UNITED STATES PATENT AND TRADEMARK OFFICE

APPLICATION NO.	FILING DATE	FIRST NAMED INVENTOR	ATTORNEY DOCKET NO.	CONFIRMATION NO.
10/740,017	12/18/2003	Michael Jackson II	706804US1	1703

Office Action Summary

DETAILED ACTION

FIG. 1

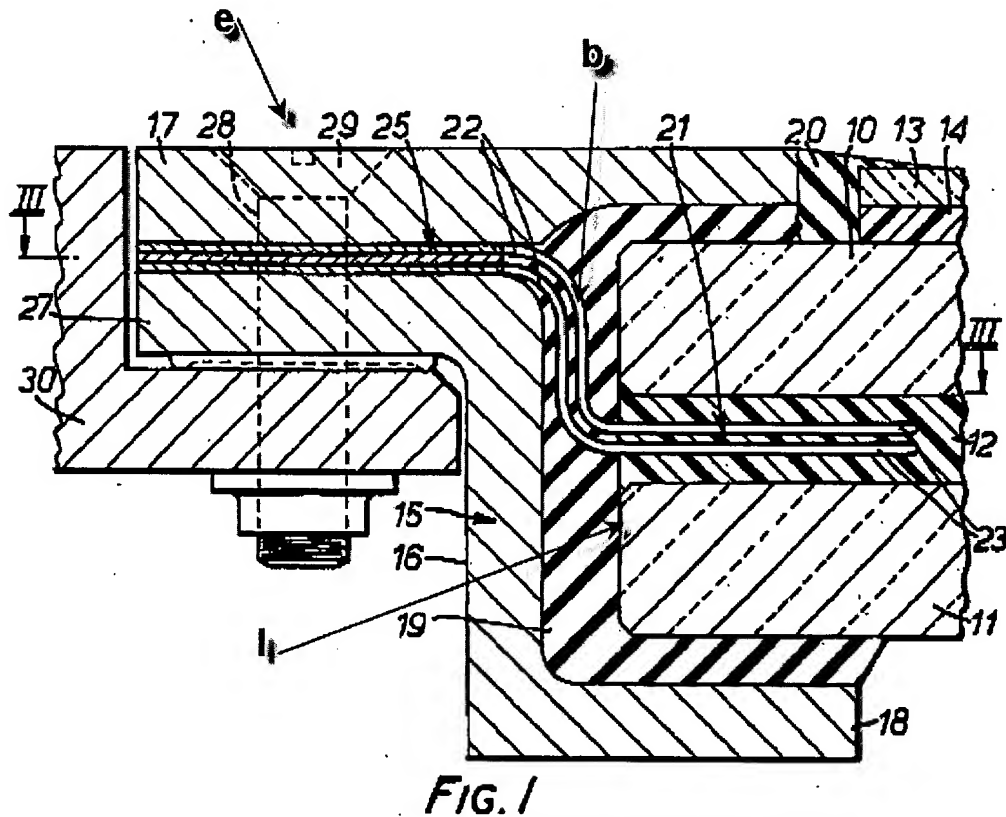
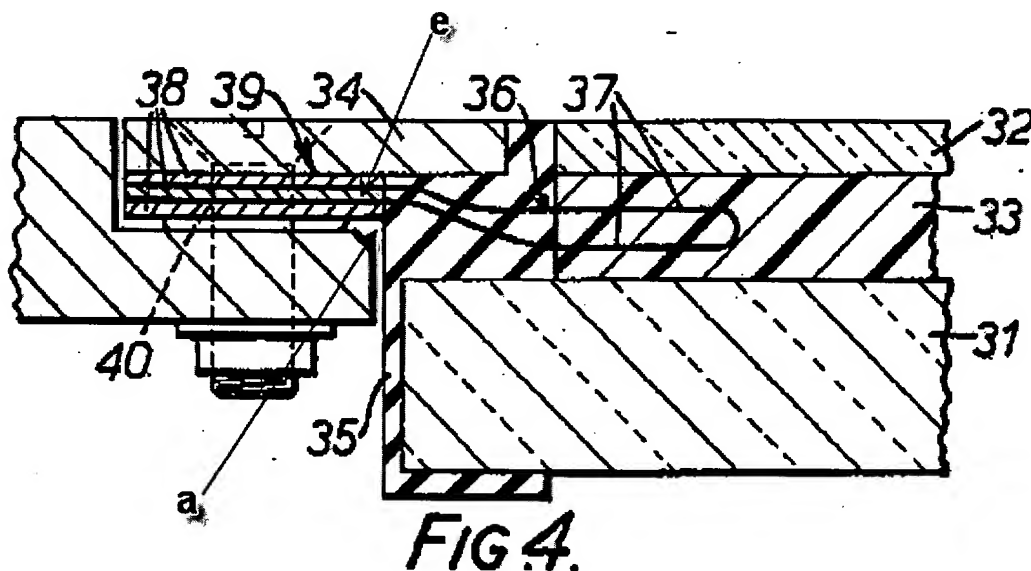
Regarding claims 1 and 16, Robert discloses a window assembly comprising: a first glass layer (10); a second glass layer (11) bonded to the first glass layer by an adhesive (12), and an engagement module (e), (annotated Figure 1).

Regarding claim 3, Roberts discloses a window wherein the engagement module (e) comprises a border (b) that is received between the first (10) and second (11) glass layers to bond the engagement module to the first and second glass layers and a central hub (16), (annotated Figure 1). The phrase "adapted to engage the window opening mechanism" is considered intended use and is given no patentable weight.

Regarding claim 7, Roberts discloses a window wherein the central hub (16) comprises an aperture (28), (annotated Figure 1). The phrase "for lockingly engaging the window opening mechanism" is considered intended use and is given no patentable weight.

Regarding claim 8, Roberts discloses a window wherein the engagement module (e) is bonded to a lower edge (l) of the window, (annotated Figure 1). The phrase "for

Regarding claim 10, Roberts discloses a window wherein the engagement module (e) comprises a border (b) for bonding between the first (10) and second (11) glass layers and a central hub (16), (annotated Figure 1). The phrase "adapted to engage the window opening mechanism" is considered intended use and is given no patentable weight.
